Subject: Retail @ 7 Bar Traffic Impact Study

NM 448 (Coors Road) and 7 Bar Loop (MP 5.79)

This letter is to inform you that the **FINAL** Traffic Impact Study (TIS) for Retail @ 7 Bar dated January 2024 has been reviewed. The proposed development is located east of NM 448 (Coors Rd) and 7 Bar Loop.

# EXHIBIT A

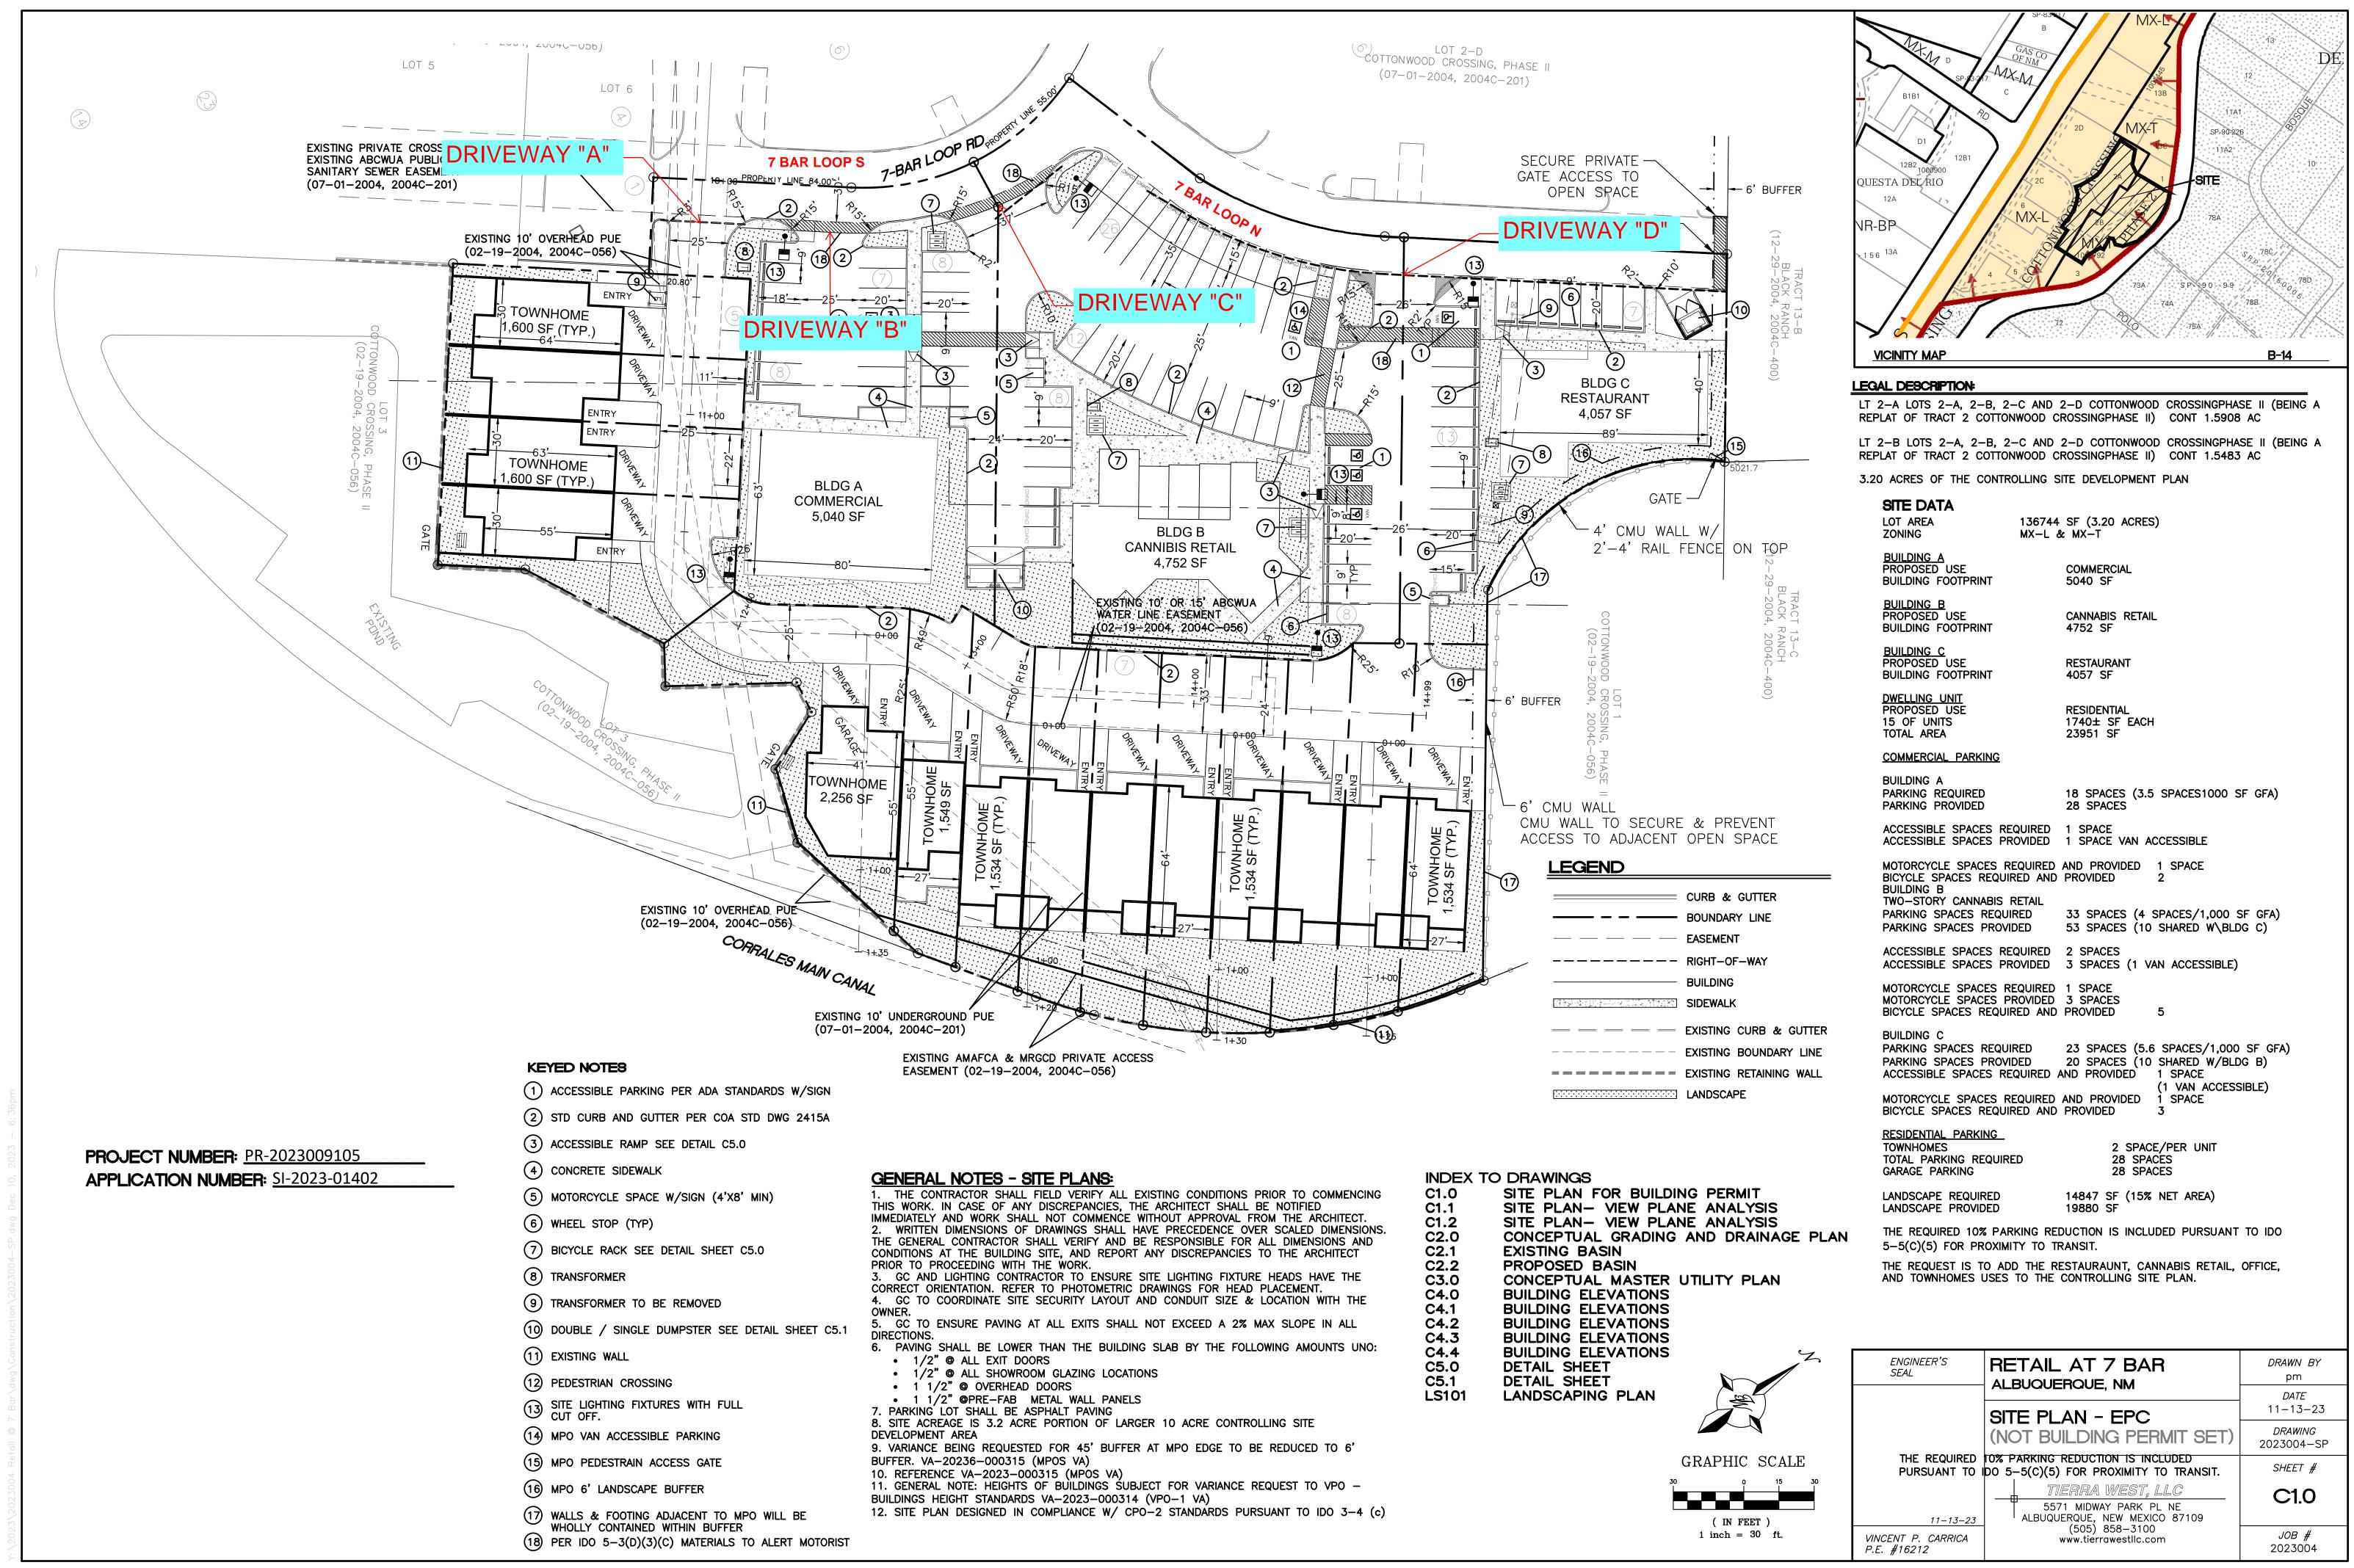
The NMDOT has no objection to the use of its existing access points on 7 Bar Loop. See Exhibit A for the site plan and project plats for this development. TIS recommendations are shown in Exhibit B. Based on these analyses, the following conditions are required:

- 1. The property owner shall obtain a shared access permit for its access easement to NM 448 via Seven Bar Loop extension to the east.
- At the signalized intersection of NM 448 (Coors Road) and 7 Bar Loop, the development
  - Shall design and install interconnect on NM 448 and provide redundancy as specified by the City of Albuquerque Traffic Division.
- 3. The NMDOT shall provide final approval on the design for the offsite improvements. The developer shall agree to incorporate all the comments requested by the NMDOT.
